Form C-103
Revised July 18, 2013

WELL API NO. 30-015-37435
5. Indicate Type of Lease STATE [X] FEE []
6. State Oil & Gas Lease No.
7. Lease Name or Unit Agreement Name SRO State Unit Com
8. Well Number 007H
9. OGRID Number 229137
10. Pool name or Wildcat HAY HOLLOW; BONE SPRING
11. Elevation (Show whether DR, RKB, RT, GR, etc.) 3126' GR

JMR Services, LLC respectfully proposes the attached NOI to P&A this well on behalf of Conoco Phillips.

**Proposed P&A NOI
Conoco Phillips
SRO State Unit Com #007H
30-015-37435**

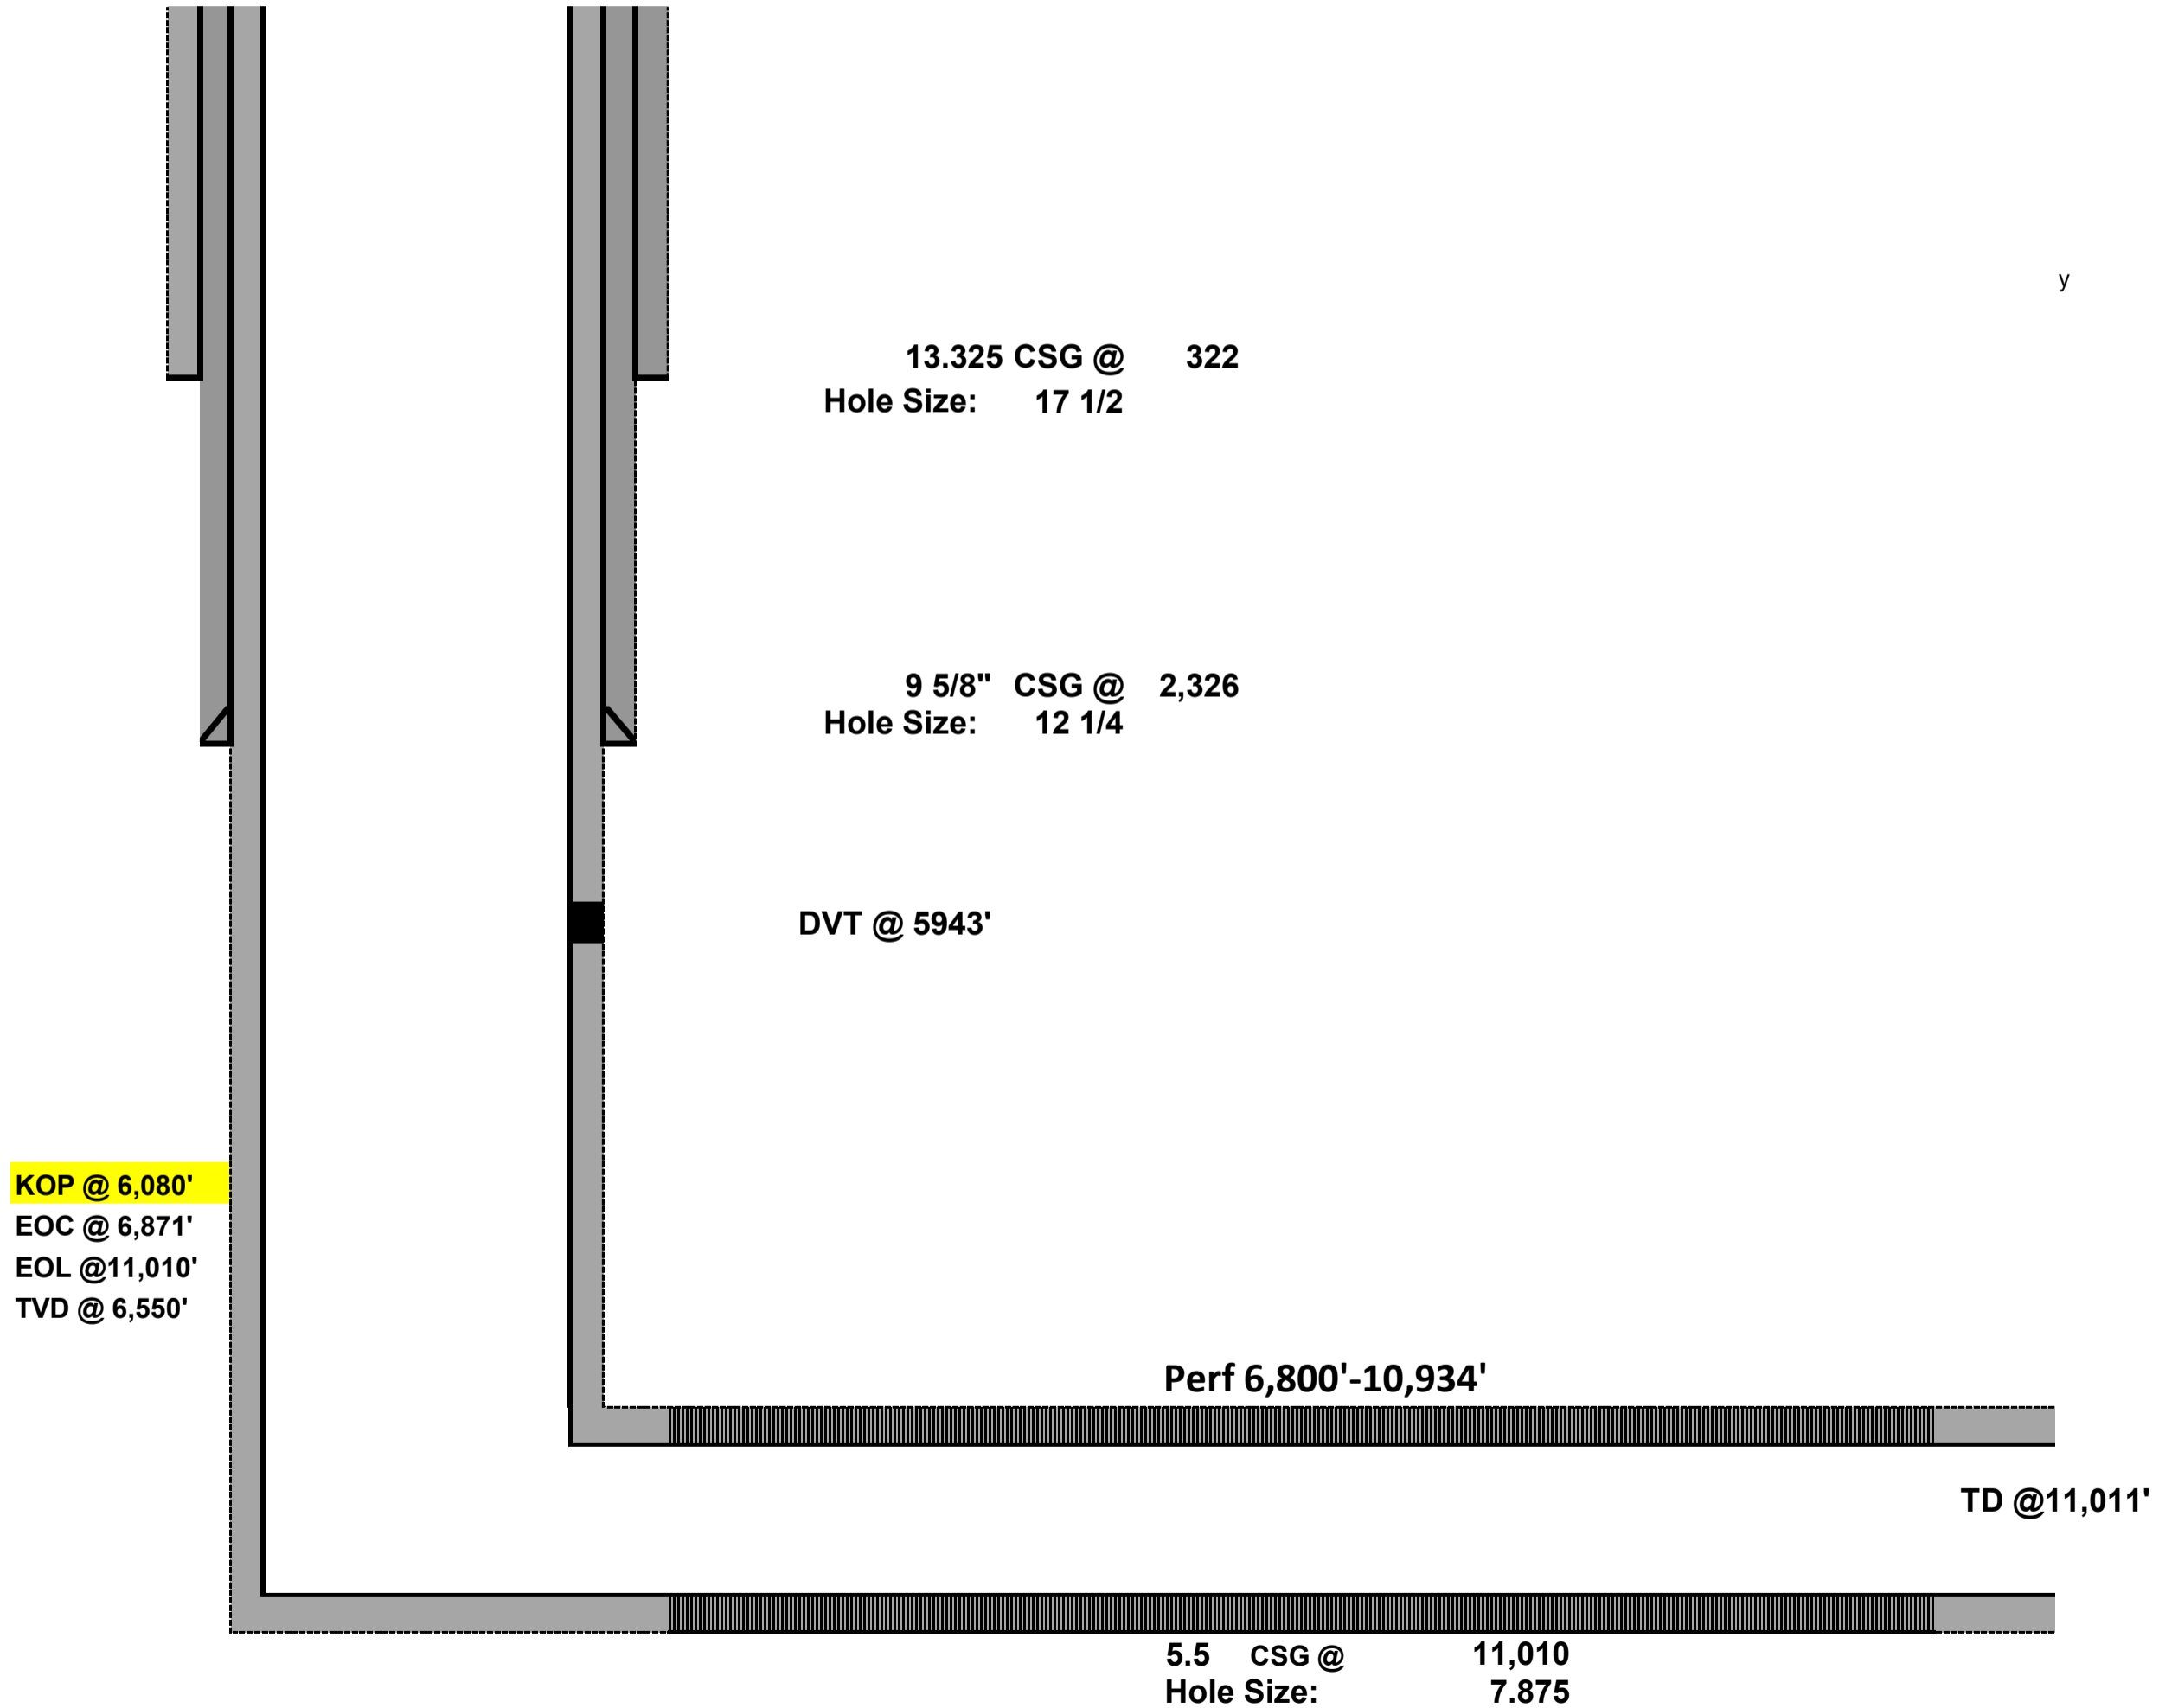
4. ND WH, NU BOP, function test BOP.
 5. RIH & set 5 1/2" CIBP at 6186'. POH. **Test Casing 500psi/30min - Bubble Test - Run RCBL to Surface with ZERO pressure**

- NOTE: Results of CBL may change the following plugs. Electronic copy of CBL to be sent to NMOCD representatives.
6. **Circulate MLF to surface**
 7. Plug #1: Bone Spring/DV Tool: With CIBP @ 6186', Spot 67 sxs cement w/ 2% CaCl from 6186' to 5993'. WOC & Tag.

8. **Spot cement 5125' - 5025' - T Brushy Canyon**
 9. Plug #2: Cherry Canyon formation top: Spot 41 sxs cement w/ 2% CaCl from to 3375' to 3275'.
 10. Plug #3: Bell Canyon formation top: Spot 41 sxs cement w/ 2% CaCl from 2421' to 2321'.

11. 5/8" Plug #4: Bsalt Spot 72 sxs cement w/ 2% CaCl from 2238' to 2025'. - **Perf 2376' Sqz cmt to 2025' - 9 5/8" Shoe - WOC & Bubble Test**
 12. Plug #5: Tsalt, Shoe, & Surface plug: Sqz 186 sxs cement from 642' and circulate cement to surface. **WOC & Bubble test**

**APPROVED
GC 12/12/25**
